ADDENDUM NO. 4

F.G.A. No. 21003

ROOMS TO GO – OFFICE RENOVATION & EXPANSION

September 16, 2021

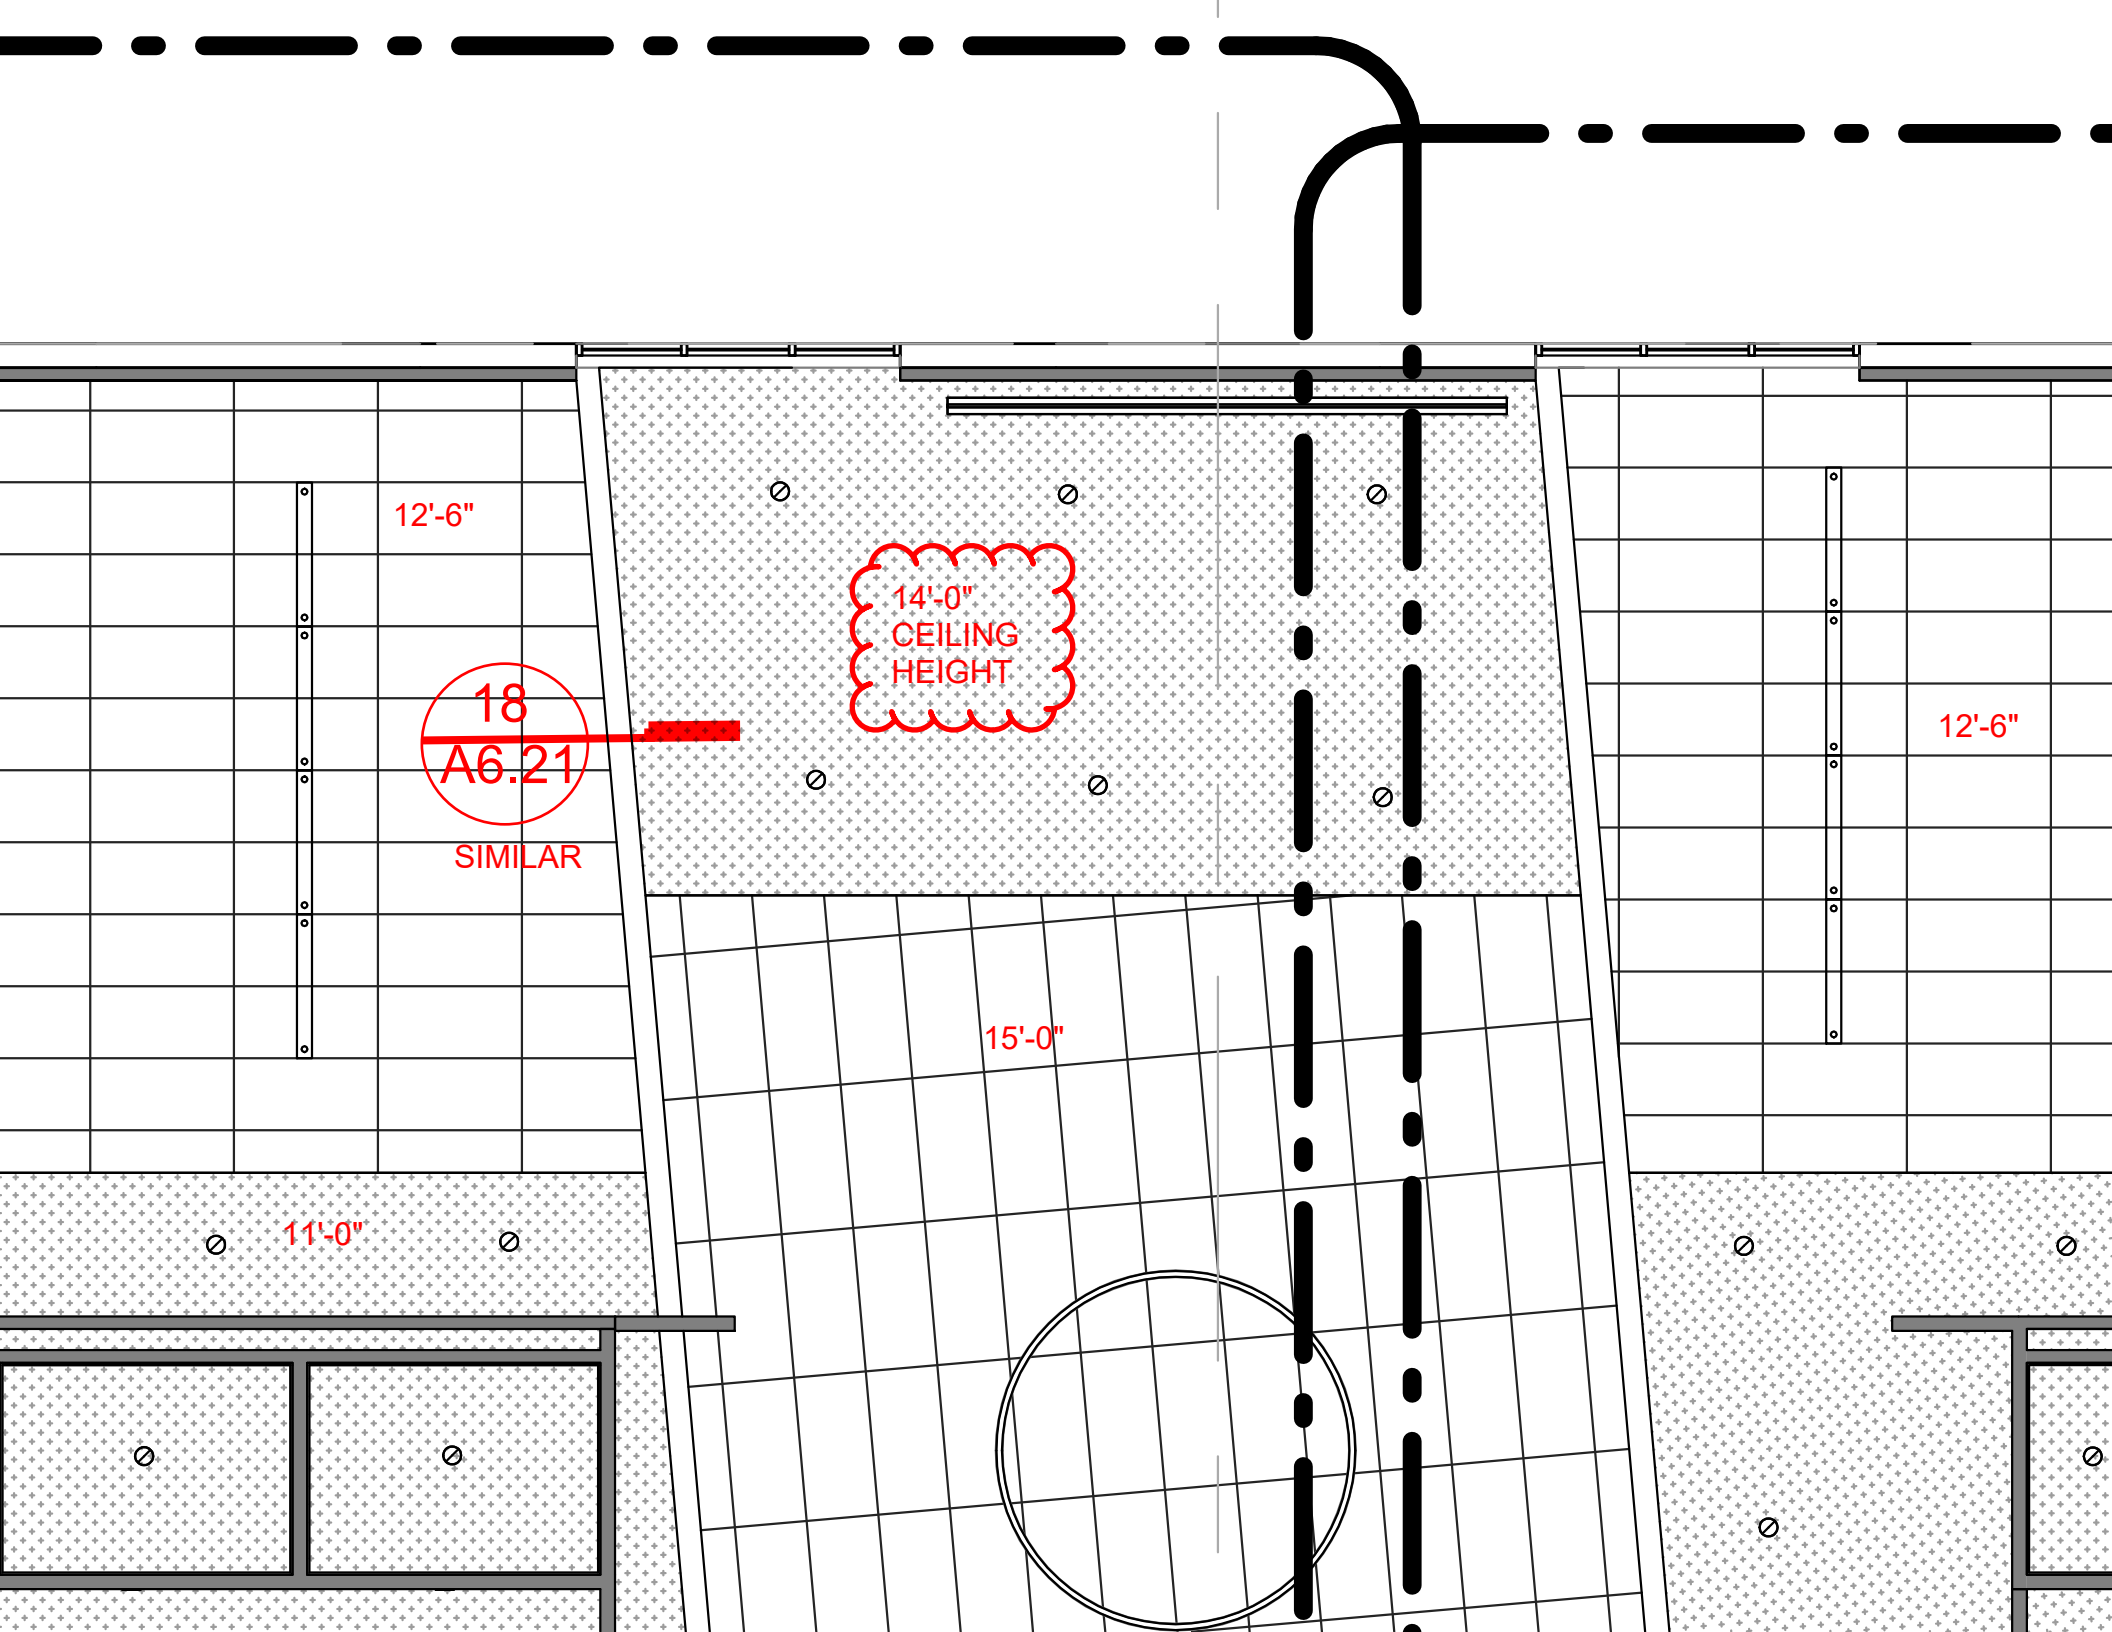
- Item 1: Refer to Sheet A8.01D – Reflected Ceiling Plan D and Sheet A8.01E – Reflected Ceiling Plan E :
CLARIFICATION: The area of GWB Ceiling in the IT Break Room is to be 14”-0” high as indicated on the attached partial ceiling plan sketch.
